Our Ref: L.S20319.07.01.Letter in Support of Revised Master Plan

2 September 2019

RE: LETTER IN SUPPORT OF REVISED MASTER PLAN FOR IVANHOE ESTATE

Figure 1 Ivanhoe Estate Masterplan (Bates Smart Architects 2019, drawing reference DA02.MP.002[11])

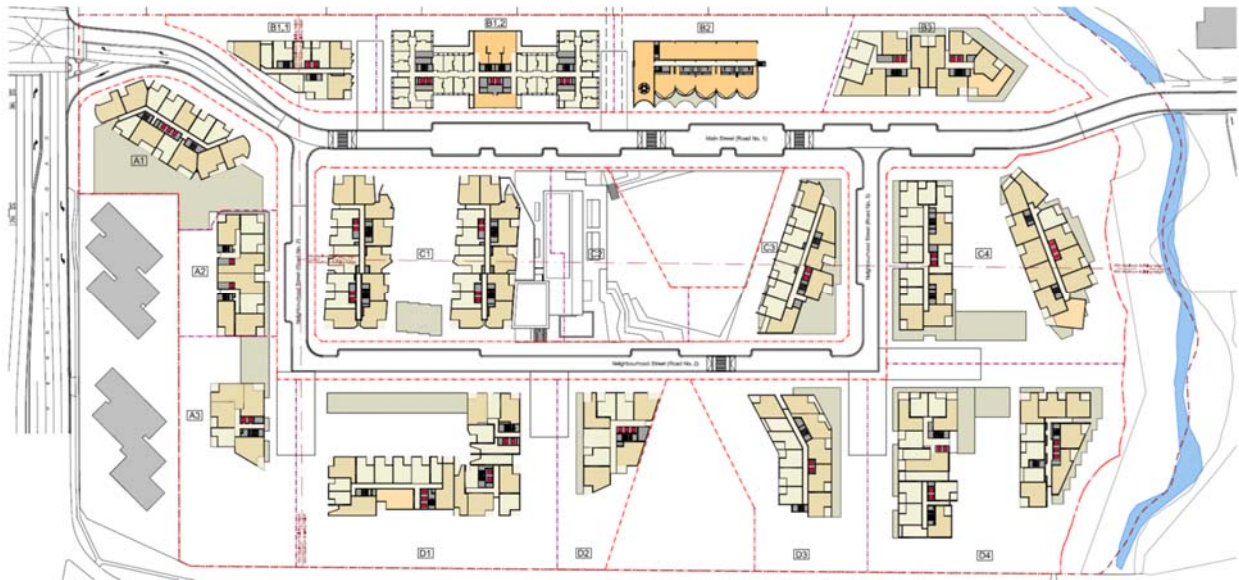
Subsequent to the flood impact assessment reference above, the Master plan has undergone revision. BMT have reviewed the revised Master Plan for Ivanhoe estate (Figure 1) illustrating changes to building footprints and vehicle carriageway. Of note, are the changes in building footprint within the confines of the Shrimptons Creek corridor (Buildings B3, C4 and D4).

Title:
Peak Flood Depth - Developed Scenario
100 yr ARI

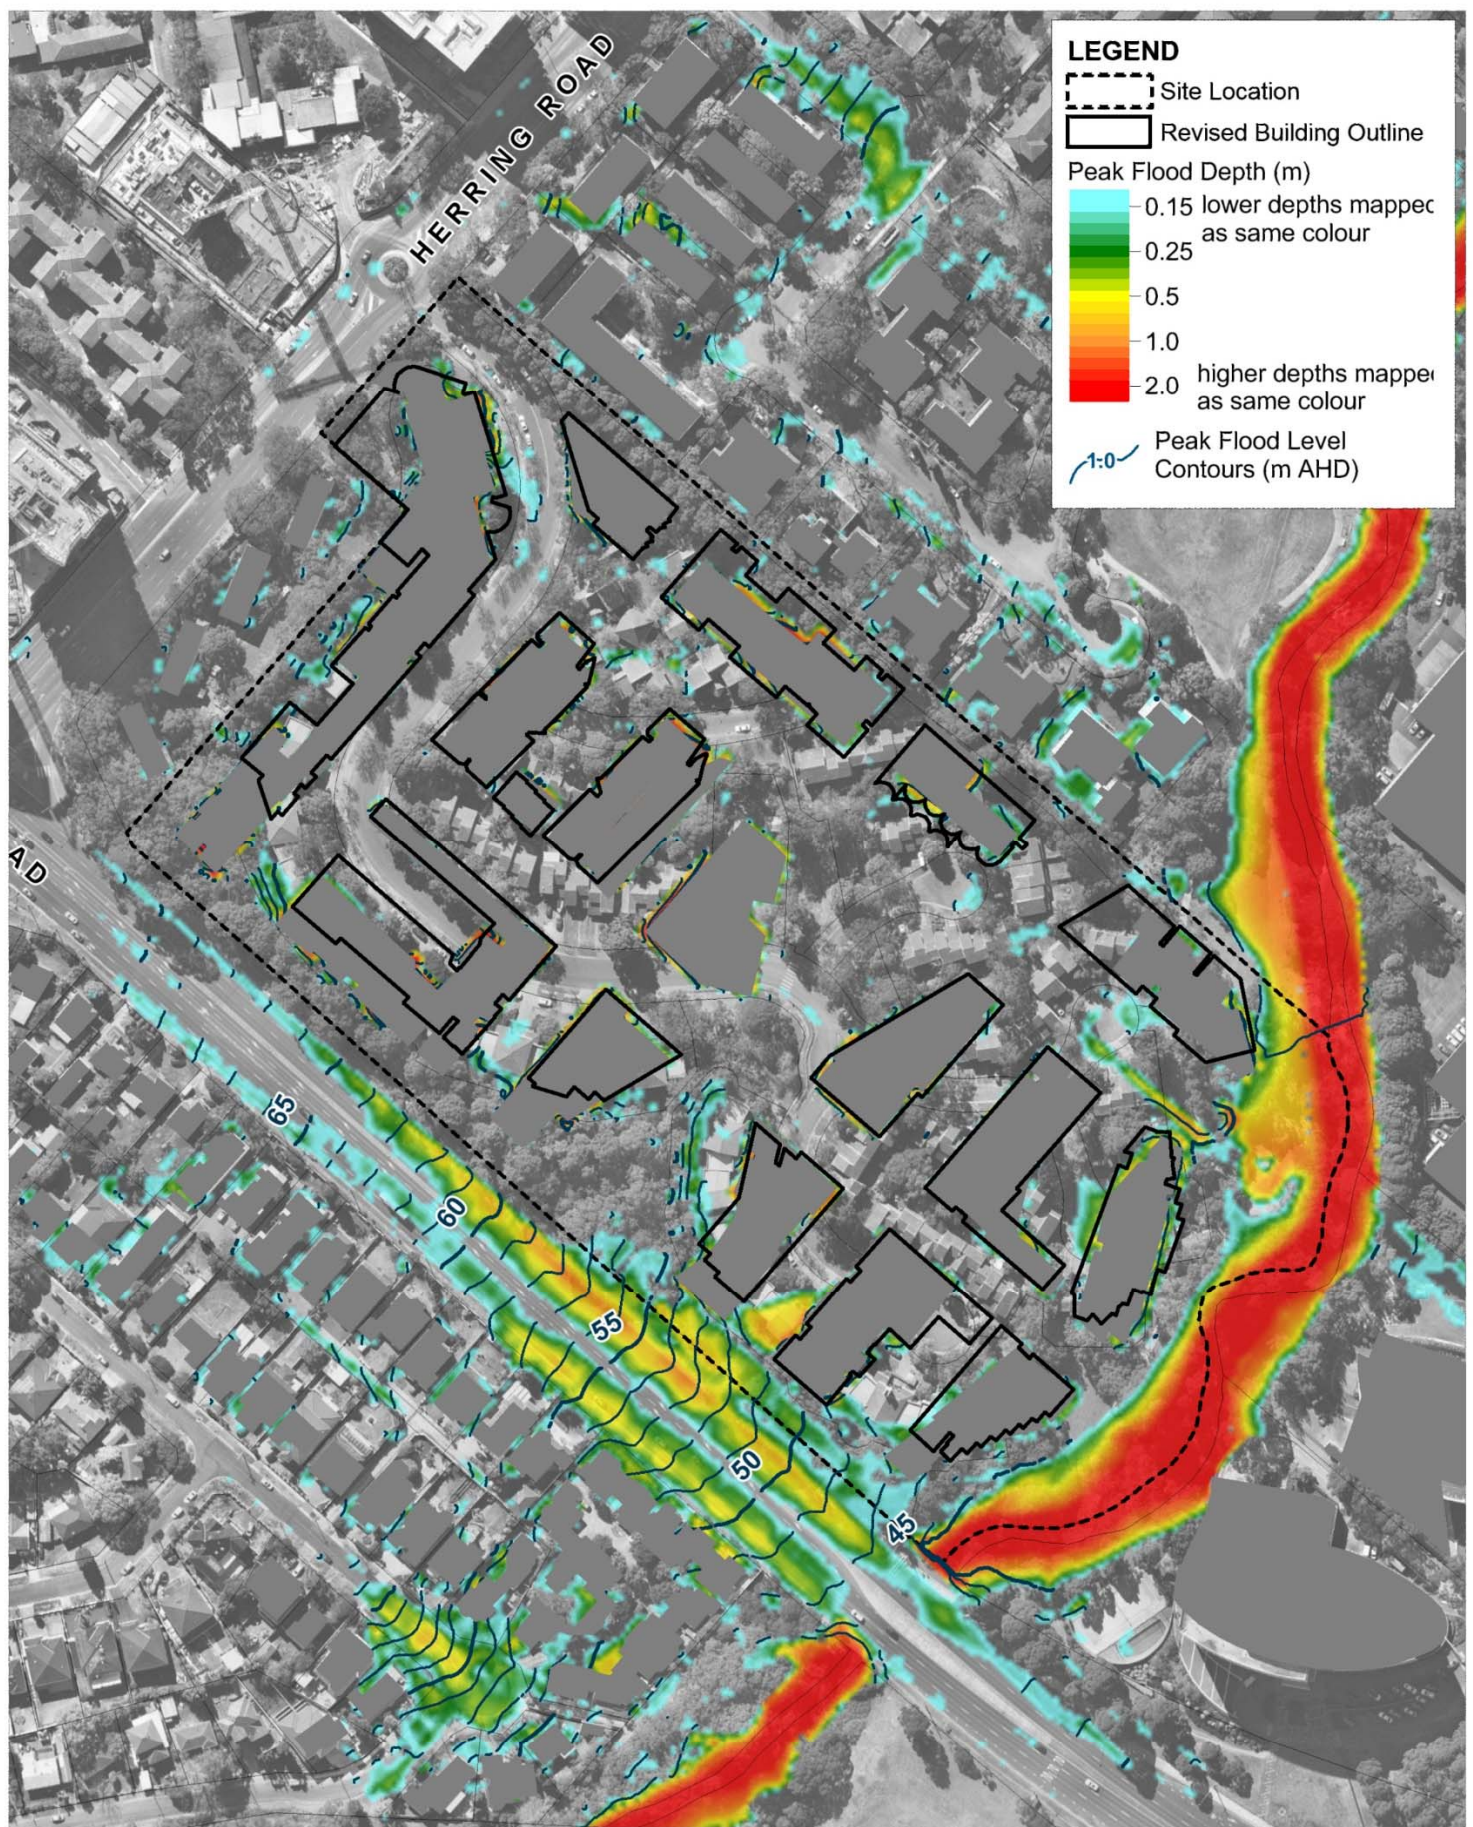
The revised building footprints have been overlaid on the modelling undertaken for the flood impact assessment (Attachment 1). It is BMT's view that the revised Master Plan does not pose any adverse change in flood regime (overland or otherwise) outside of those already documented in report *L.S20319.03.Flood Impact Assessment for Ivanhoe Estate Masterplan*, on account of the following:

- Buildings B3, C4 and D4 are located outside the 100 year ARI flood extent for the Shrimptons Creek corridor;
- The revised building extents retain the hydraulic characteristics of the floodplain;
- All other buildings are located outside of the Shrimptons Creek corridor, noting that these areas do not pose a risk due to flooding, as per the findings of the previous Master Plan flood impact assessment.
